Department of Conservation and Development
County Planning Commission
Wednesday, May 14, 2025 – 6:30 P.M.

STAFF REPORT

Project Title:	19 Jay Court Tree Permit Appeal
County File(s):	CDTP24-00064
Appellant:	Robert J. Eisele
Applicant	Carlos Ramirez, ArborTech Tree Care Inc. (Applicant)
Owners:	Bruce & Grace Ginn (Owners)
General Plan:	Single-Family Residential-Low Density (SL) (Residential Low Density (RL))
Zoning:	P-1, Planned Unit District
Site Address/Location:	19 Jay Court in Alamo, CA (APN: 193-670-016)
California Environmental Quality Act (CEQA) Status:	Categorical Exemption – Class 3: CEQA Guidelines, Section 15303(e), new construction of an accessory structure.
Project Planner:	Nai Saephan, Planner I, (925) 655-2874 nai.saephan@dcd.cccounty.us
Staff Recommendation:	Deny the Appeal and Approve the Project (See Section II for full recommendation)

TITLE
MOUNTING PLAN

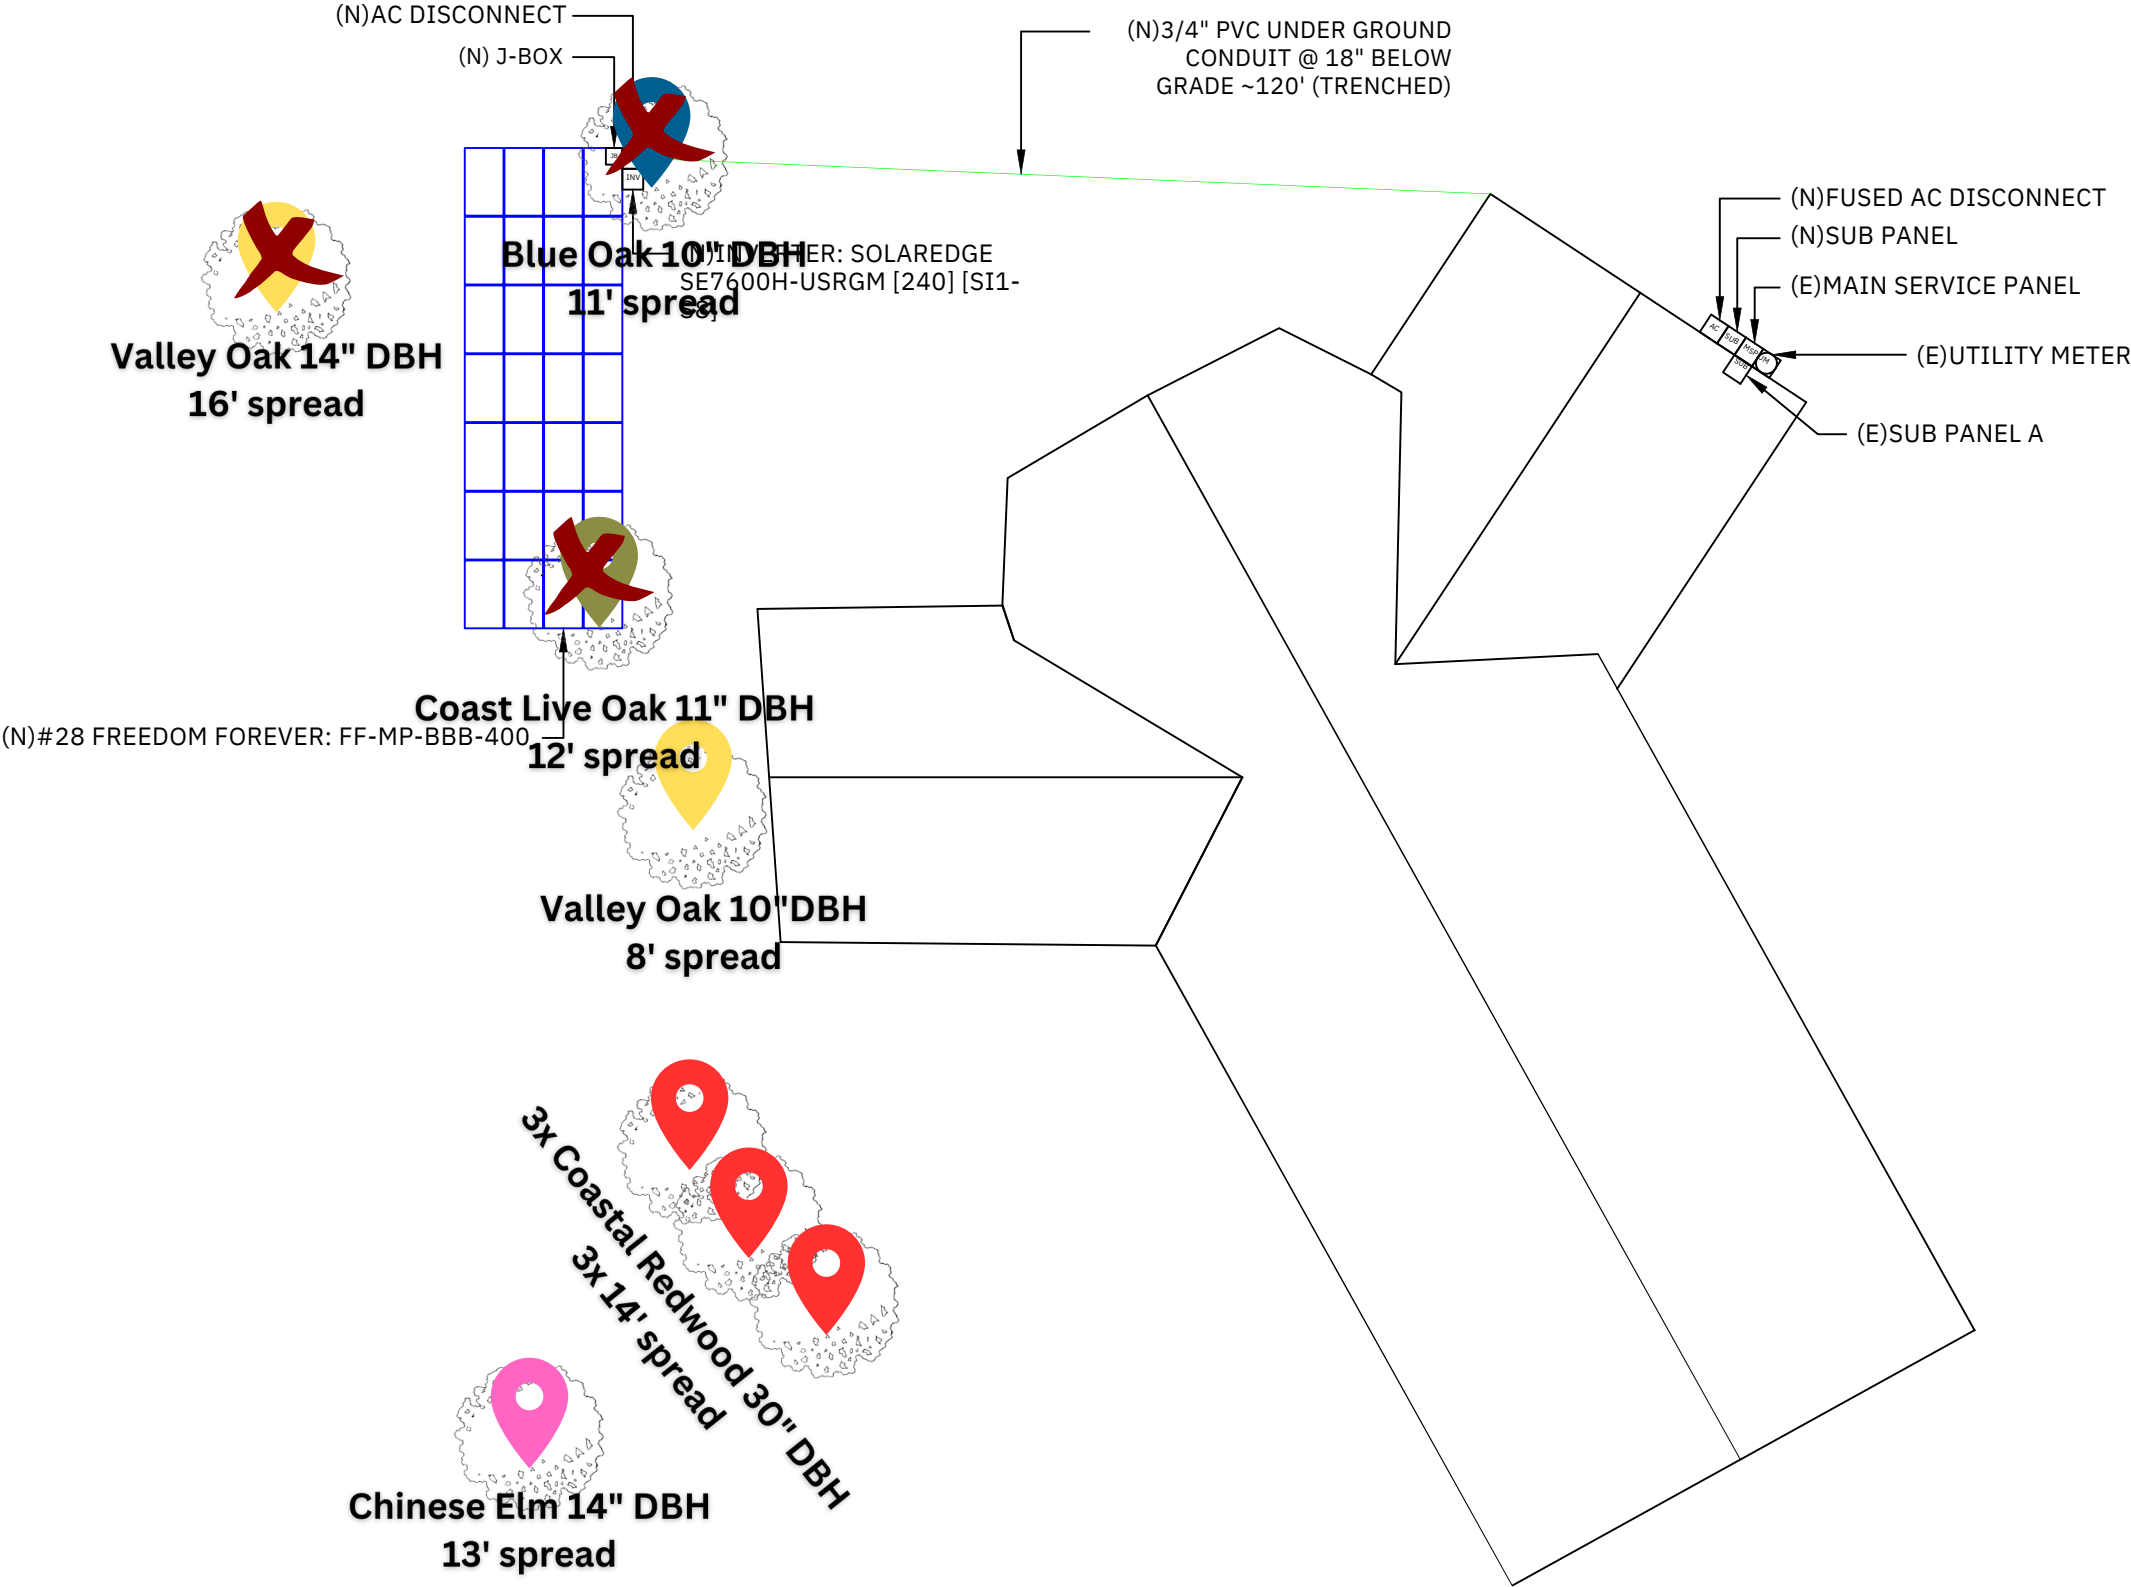
One other challenge on the Coastal Oak Tree: The Coast Oak is listed (Construction Plans, page2, The Mounting Plan) as having only a 12' spread, that is clearly wrong, more like twice that.
